From: dustin@dmroma.com
Sent: Thursday, July 10, 2025 10:10 AM
To: Amanda L. Lessard
Cc: Stephen J. Puleo; Mark T. Arienti
Subject: Response to Staff Review - Shepherd Lane Subdivision
Attachments: Unit 1 plan Shepherd Lane.pdf

In response to your staff review memo dated July 8th for the Shepherd Lane Subdivision:

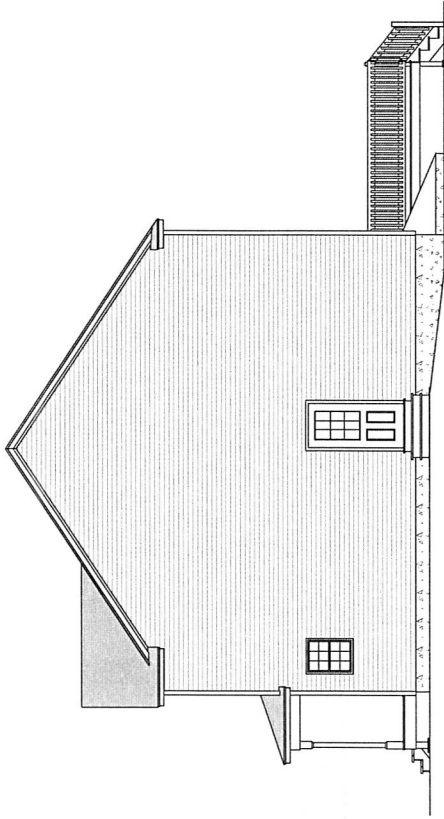
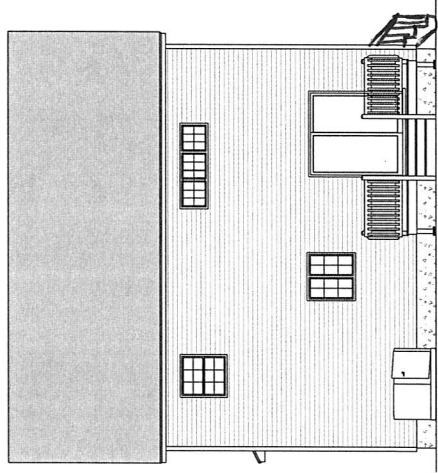
- a. The attached plan for Unit 1 includes a full-length porch along the front of the house to bring it all the way to the front corner. If necessary we can add a set of stairs on the end of the porch facing Falmouth Road so that it has an access point facing the public street.
- b. The attached plan for Unit 1 includes larger windows facing Falmouth Road (left elevation) to meet the 25% fenestration requirement.
